Report to Council

**Planning Application TP-2017-606
2-50 Elizabeth Street and 2-12 Barrett Street, Kensington
(Former Younghusband Wool Store)**

12 December 2017

DELEGATED PLANNING APPLICATION REPORT

1 STAGE 01 - DEMOLITION - EAST ELEVATION - ELIZABETH STREET

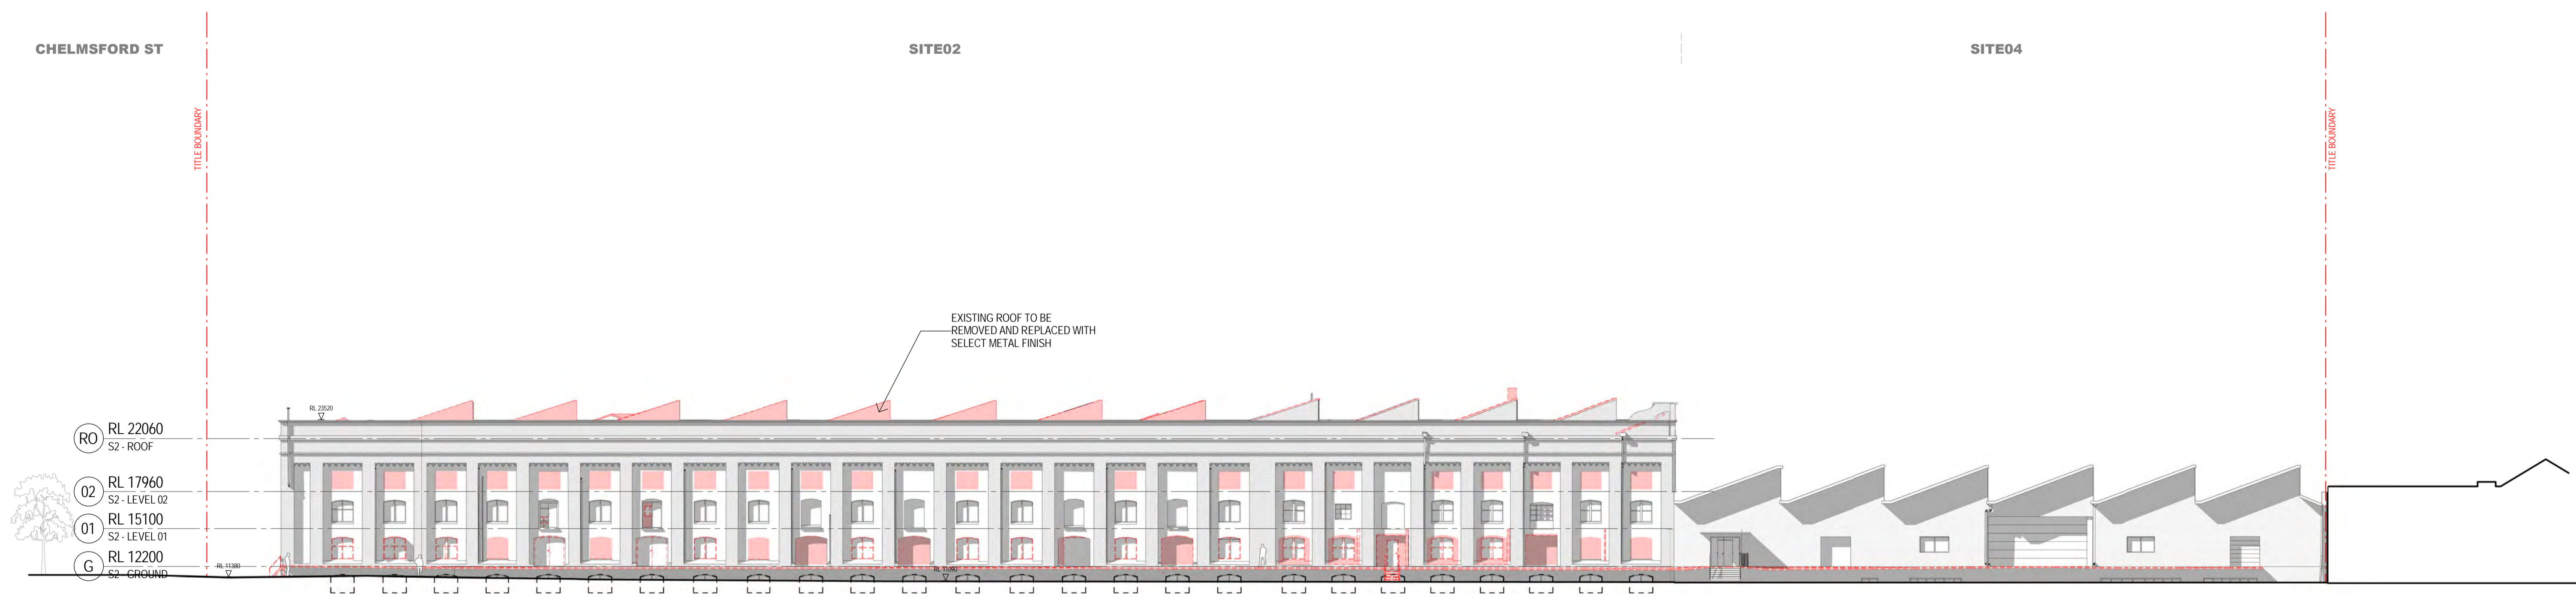
- To provide for an opening to the sky terrace, removal of approximately one third of the saw-tooth roof to the 1917 section of Wool Store 1.
- A new façade to the Elizabeth Street frontage of the existing three storey bridge link. The proposed façade is not shown on the Elizabeth Street elevation.

3. This bridge forms part of the original fabric and the Level 1 streetscape in Elizabeth Street. The proposed elevations indicate a “new façade to existing bridge link”, but show no change on the Elizabeth Street (east) elevation. No elevation is provided for the west elevation of this bridge.

Recommended Condition: Delete the proposed new façade to the Elizabeth Street bridge elevation. Provide documentation for proposed changes to the west elevation, to be to the approval of the RA. (refer Condition 1g).

- g. Delete the proposed new façade to the Elizabeth Street bridge elevation. Provide documentation for proposed changes to the west elevation, to be to the satisfaction of the Responsible Authority.
